Planning Commission Study Session

SUBJECT: DR19-136, FLOWER CHILD

DR19-136, Flower Child: site plan, landscape, grading and drainage, elevations, floor plans, lighting, colors and materials for approximately 3.13 acres, generally located at the northwest corner of San Tan Village Parkway and Williams Field Road and zoned Regional Commercial (RC) with a Planned Area Development (PAD) overlay.

DRB ELEVATIONS
 - NORTH

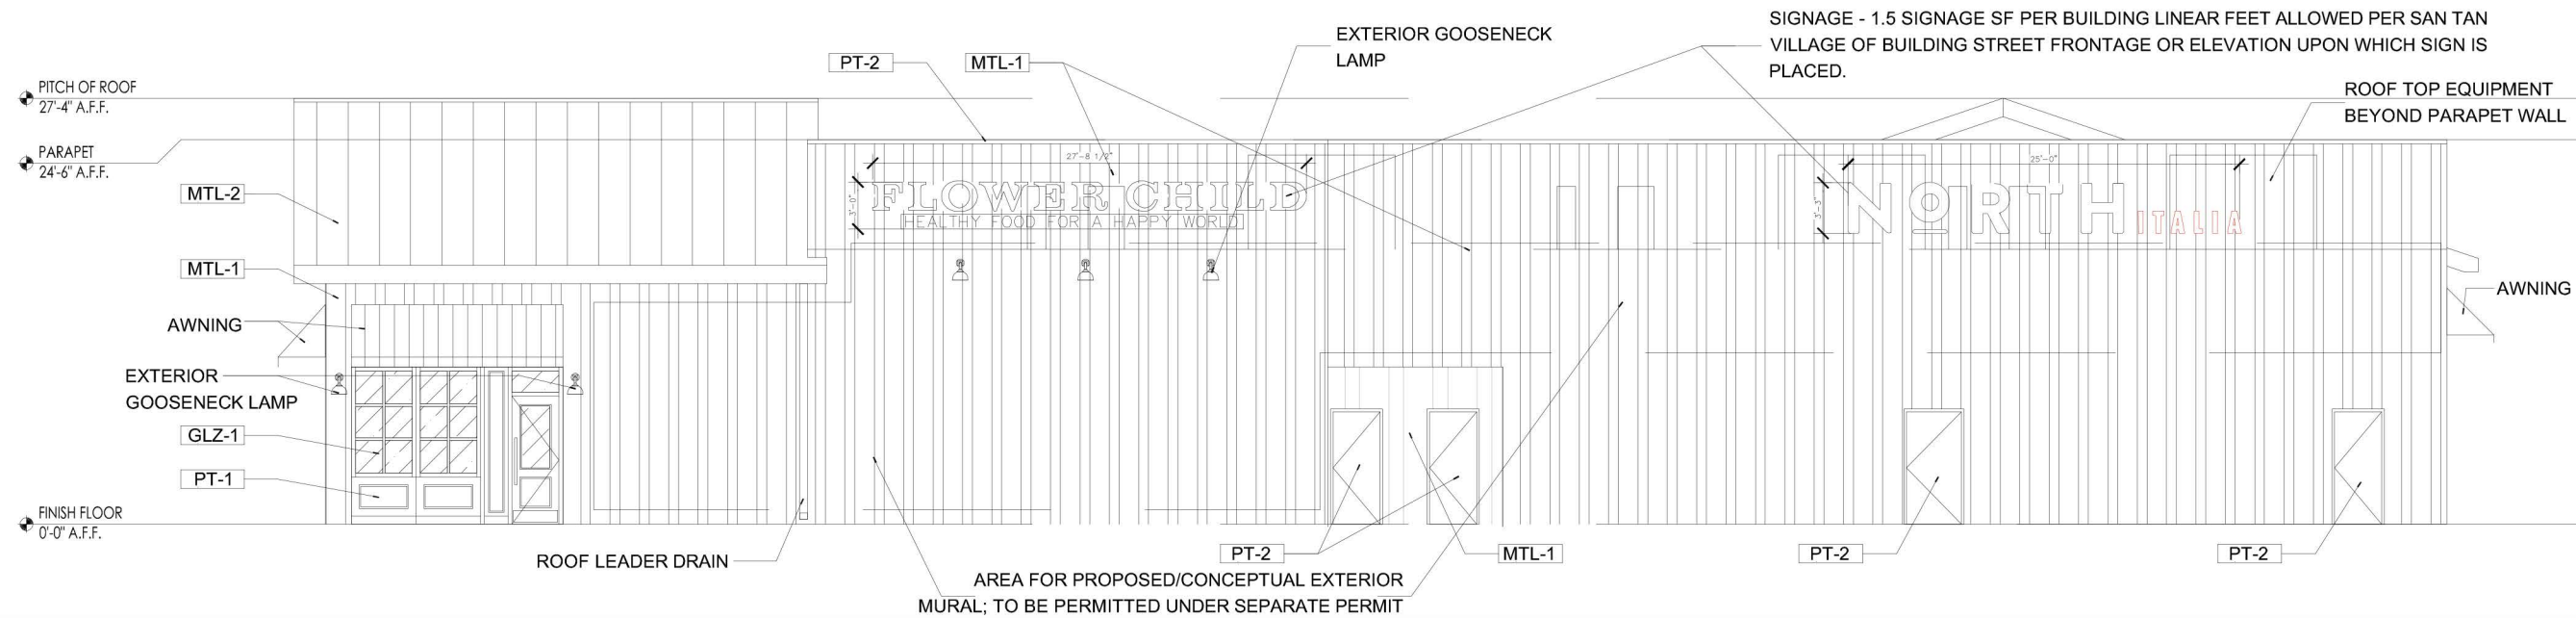
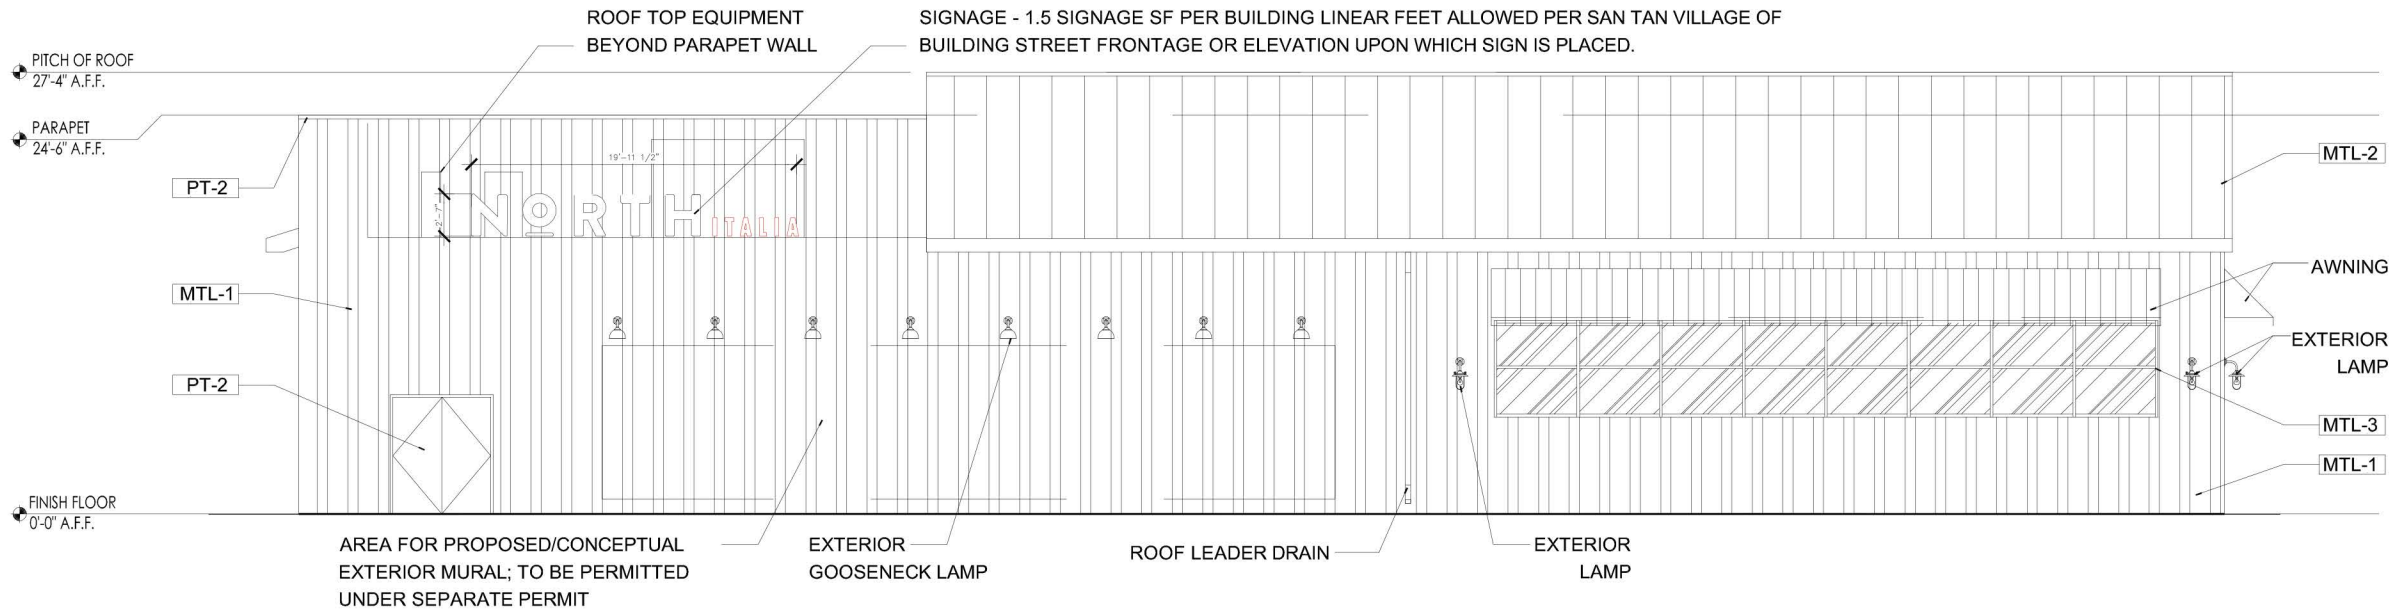
1. The color and materials of the building and the relation to the existing developments on Parcel A and the Gilbert Crossroads PAD
2. Movement and articulation of the west and north elevations.
